PL201700055
PL2017-55

EMBASSY SUITES
MINNEAPOLIS, MINNESOTA

EMBASSY SUITES
7901 34TH AVE S, BLOOMINGTON, MN 55425
AIRPORT MINNEAPOLIS, MINNESOTA

PAVING AND DIMENSIONAL CONTROL

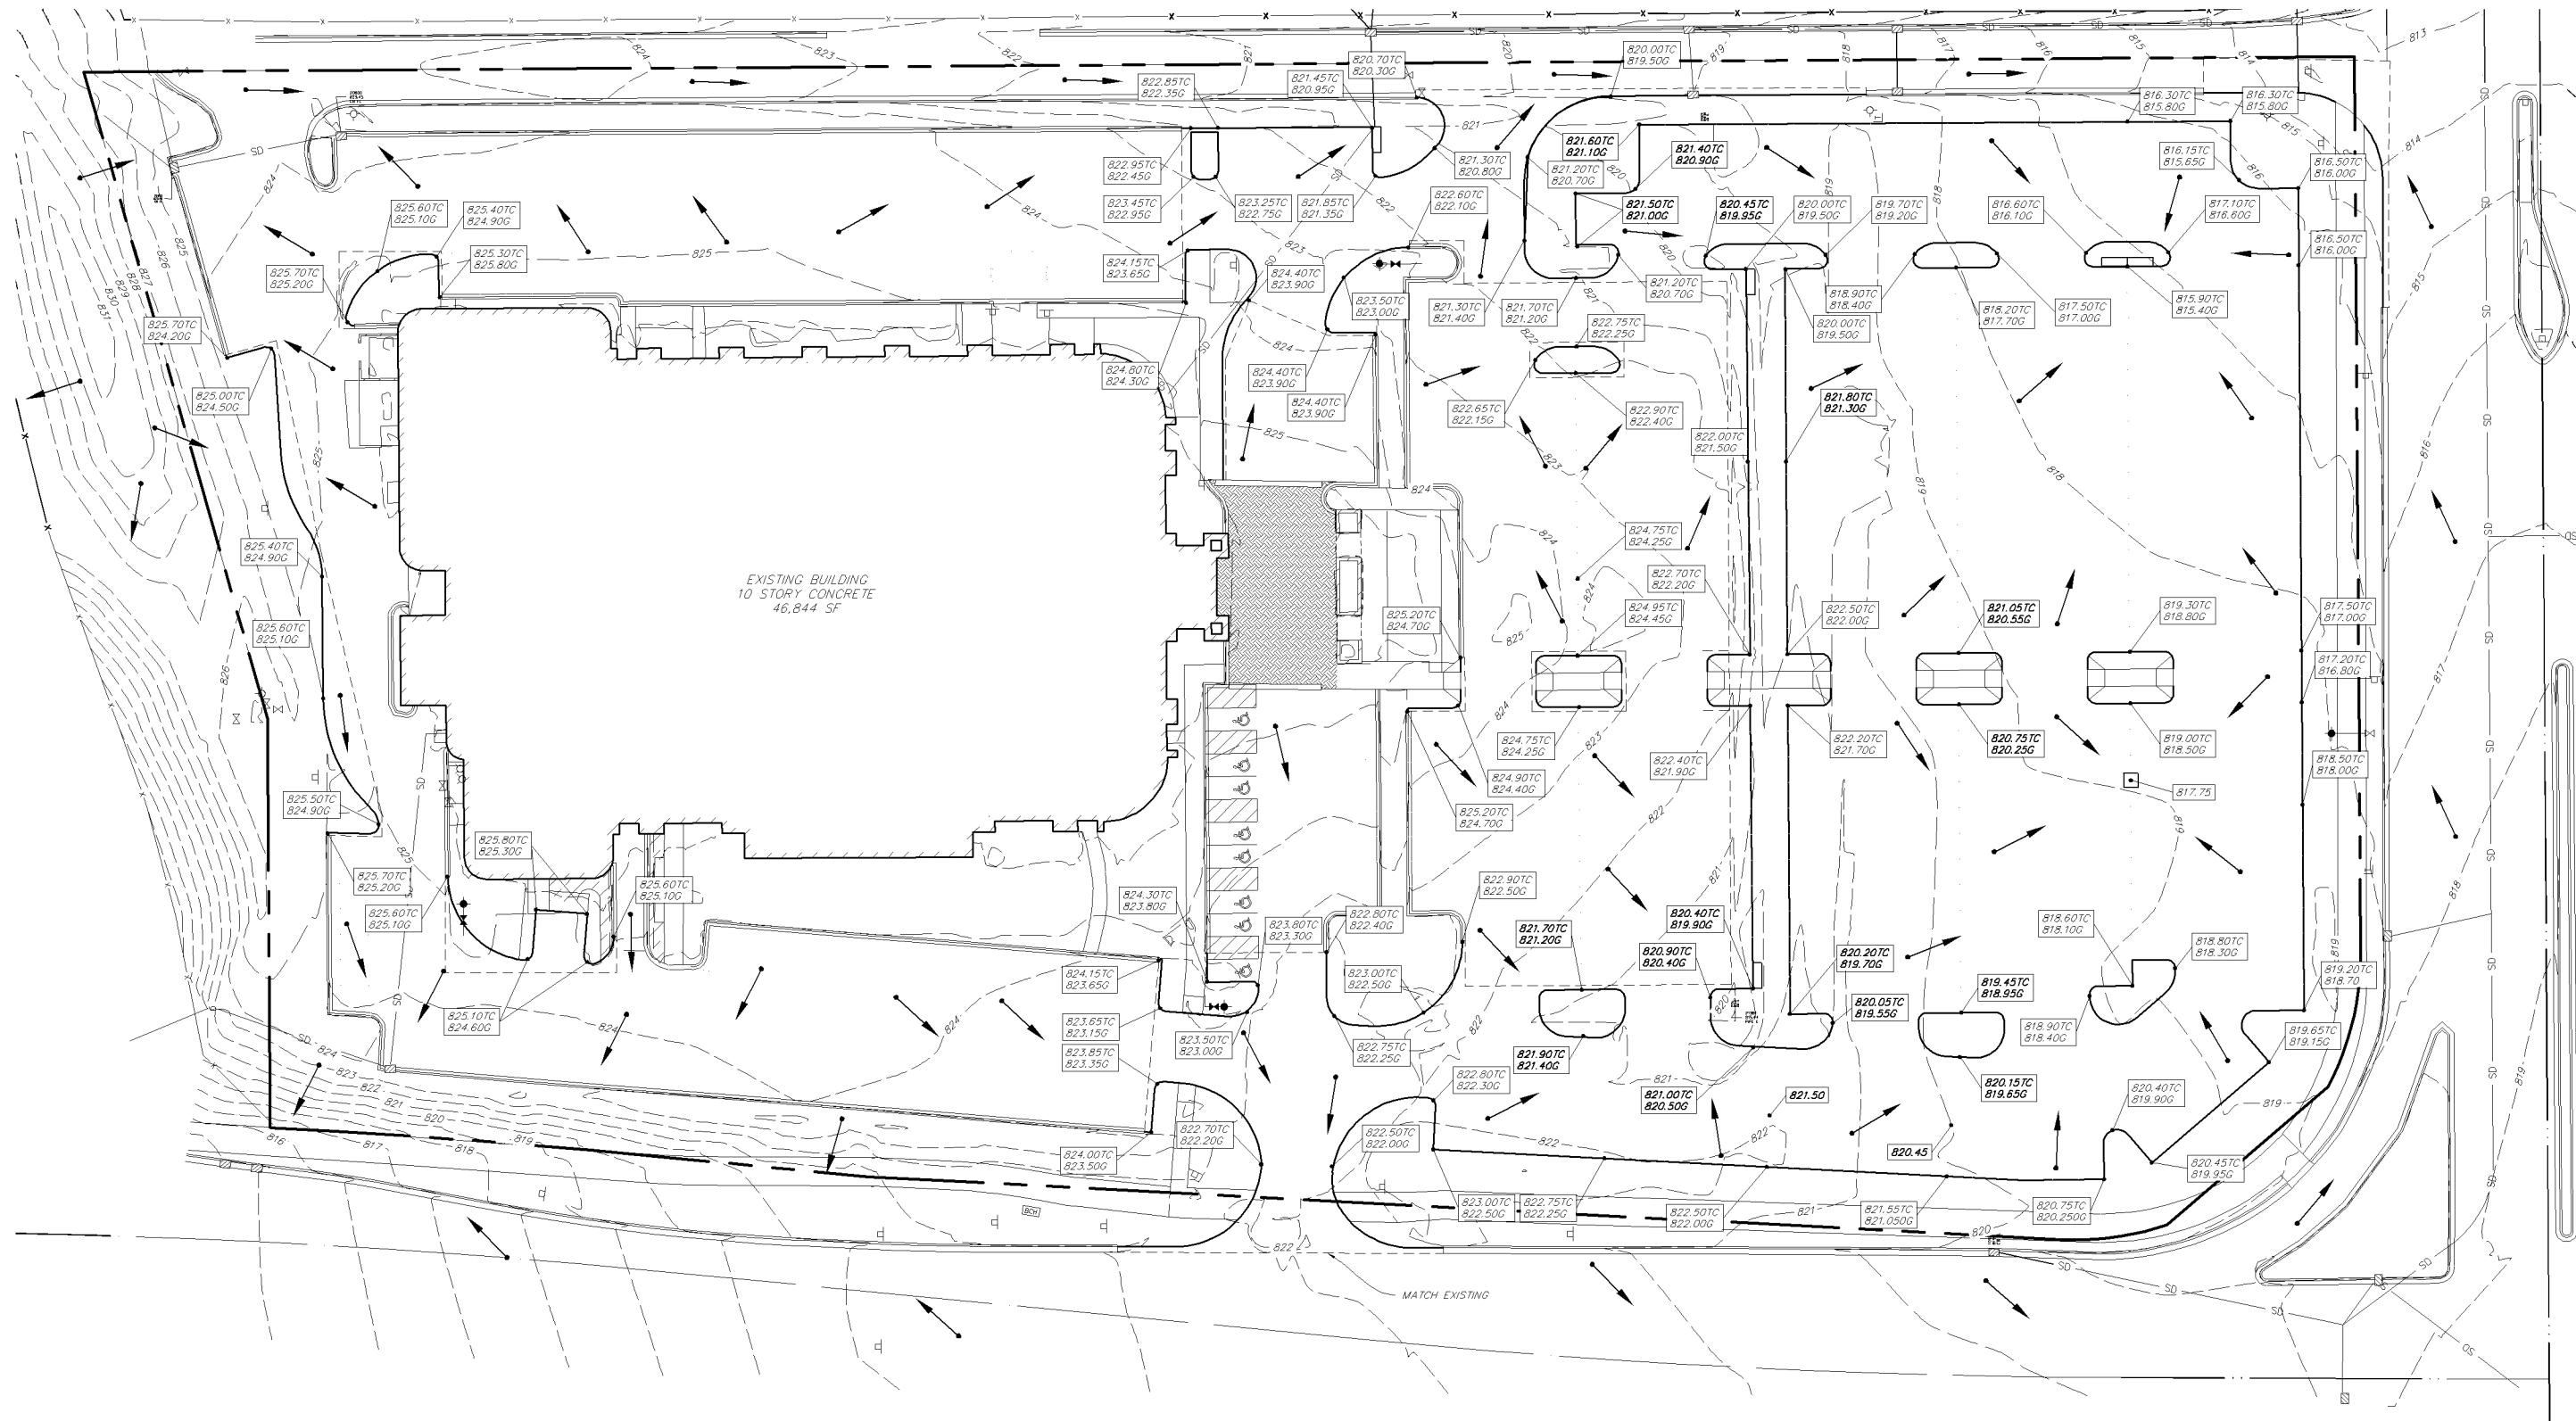
A tree is required in every parking lot island. Add at least one deciduous tree to the south parking lot island along 34th Avenue South.

POST-DEVELOPED
DRAINAGE AREA MAP

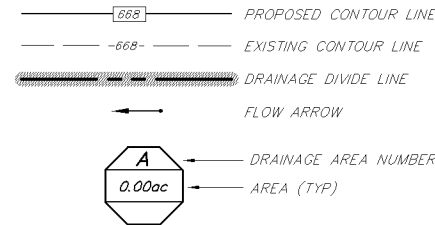
Add pavement hatch to legend

CITY STD
WATER DETAILS

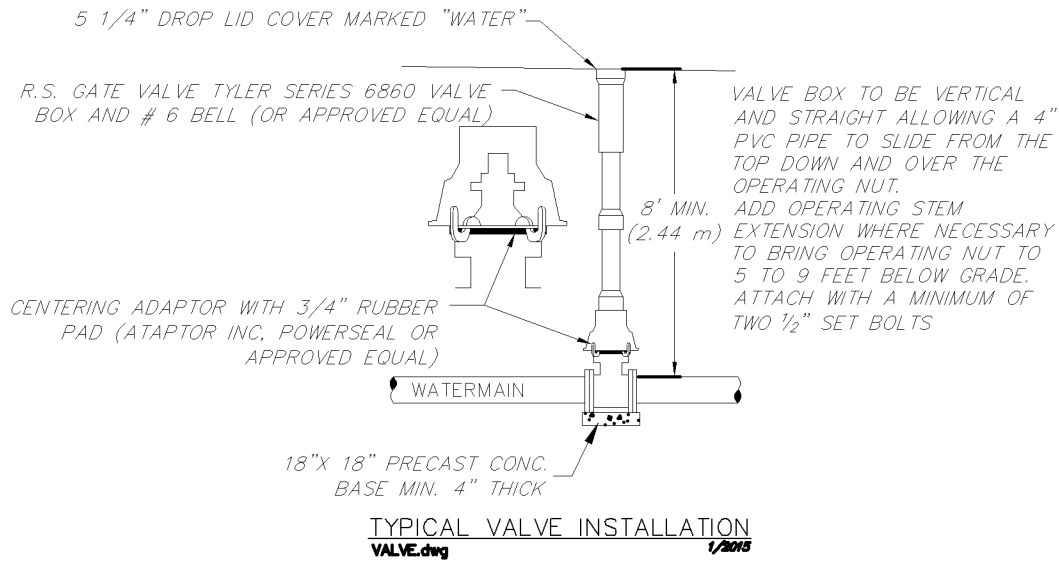
Provide details, elevations, location of building, and location of structure to be demolished. I hereby certify that this is a true, specification of the project and that I am duly licensed to perform this work under the direct supervision and that I am a duly Licensed Professional Engineer under the laws of the State of Minnesota.
